**RESIDENTIAL BUILDING PERMIT APPLICATION**

Street Address: 6388 Guilford Road Unit: \_\_\_\_\_  
 City: Clarksville State: MD Zip Code: 21029  
 Subdivision/Village/Complex Name: \_\_\_\_\_ SDP/WP/BA #: \_\_\_\_\_  
 Lot: \_\_\_\_\_ Tax Map: \_\_\_\_\_ Parcel: \_\_\_\_\_ Grading Permit #: \_\_\_\_\_

## INTERIOR RENNOVATIONS

### CHANDLER RESIDENCE

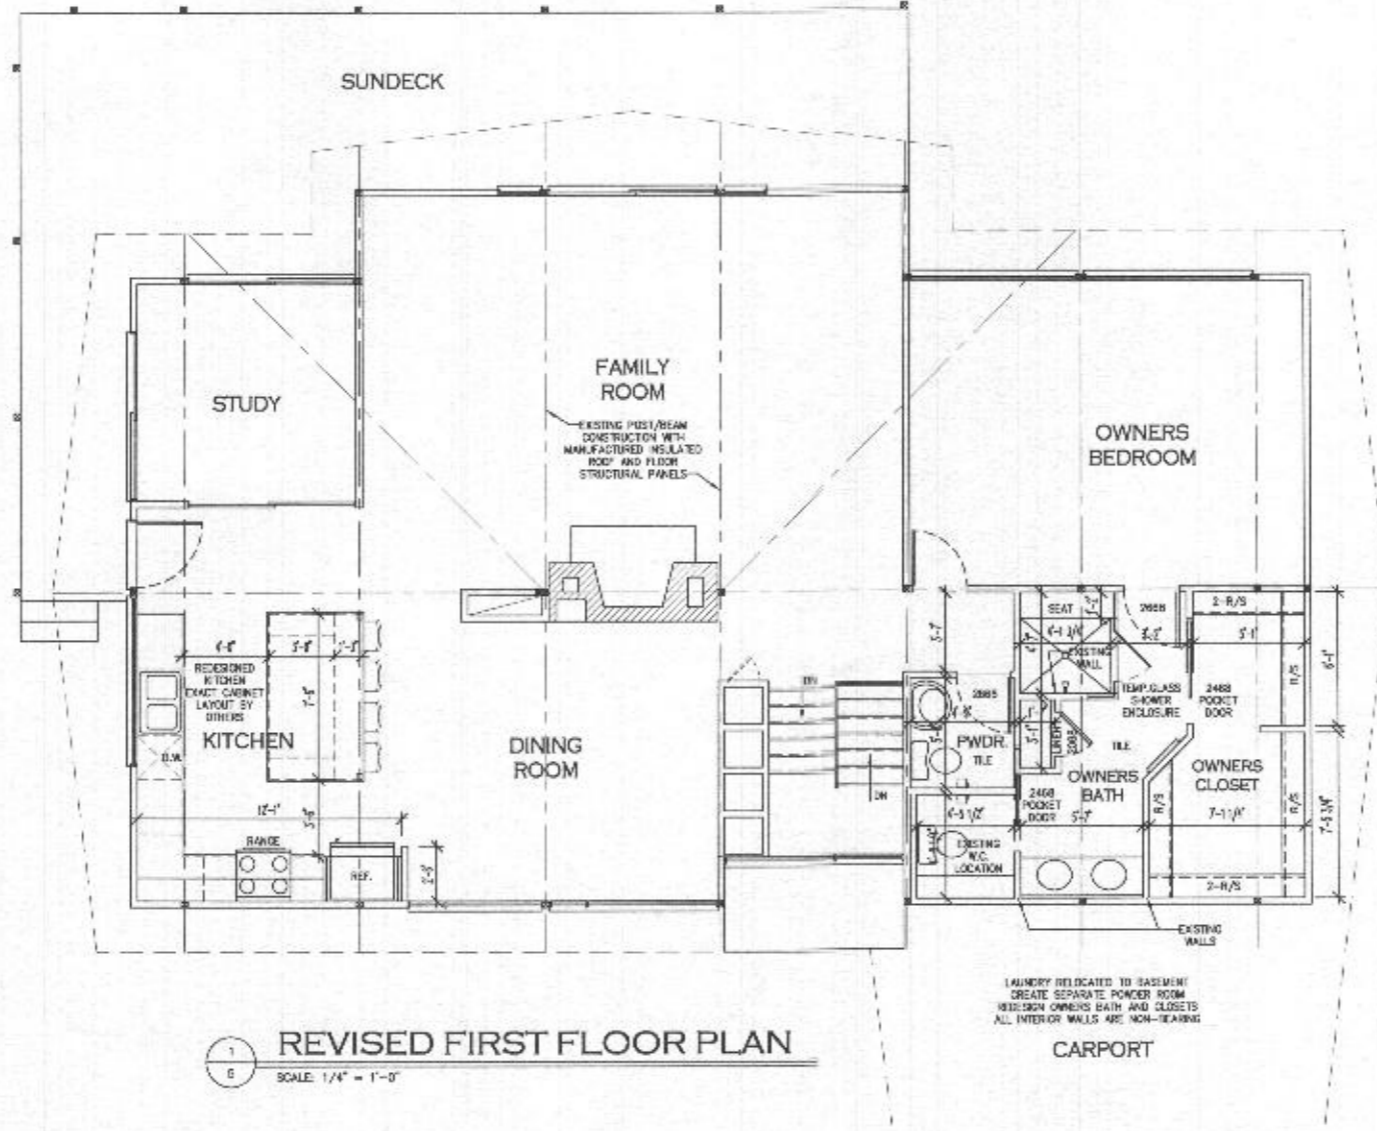
I saw the floor plan submittal dated 7.28.21 (attached), but I didn't see the revised basement floor plan in there.

Hopefully you had a chance to read over the handout attached in my initial email. It discusses our building permit review process. It also provides common reason why a perc cert plan/perc testing would be required. For living space additions including converting unfinished living space into living space or converting a non- bedroom into a bedroom by adding a window (see attached definition) would trigger the requirement to evaluate the existing system (size and condition etc.) and require perc testing in order to formally establish a sewage disposal area (for future septic system repairs) on a percolation certification plan. A bedroom addition will also likely lead to septic system upgrades. For instance, the existing septic system was designed for a 3 bedroom residence. The new floor plan shows 4 bedrooms including the master bedroom, "study", BR1 (radio room), and BR2.

With that said, to avoid these requirements, you could revise the floor plan to eliminate the window installation from the "radio" room or you may propose to convert one of the existing bedrooms into a non-bedroom by adding permanent bookcase units around perimeter of the "study" room. The easiest way to convert an existing bedroom into a non-bedroom would be to show a cased 4 ft. wide opening without doors into the room

→ I would like to amend the drawings and application to convert the basement "Radio Room" to a "Home office" and remove the addition of an Egress Window.

- REMODEL BASEMENT RADIO ROOM CHANGE TO HOME OFFICE
- ADD FULL BATH AND CLOSET
- RELOCATE LAUNDRY FROM MAIN LEVEL TO LOWER LEVEL
- REMODEL OWNERS BATH CREATING A SEPARATE POWDER ROOM
- AND SEPARATE OWNERS BATH WITH TWIN CLOSETS

- The new drawing set shows the basement "Radio Room" to be converted to a "Home Office" and my architect removed the Egress Window from the plans.
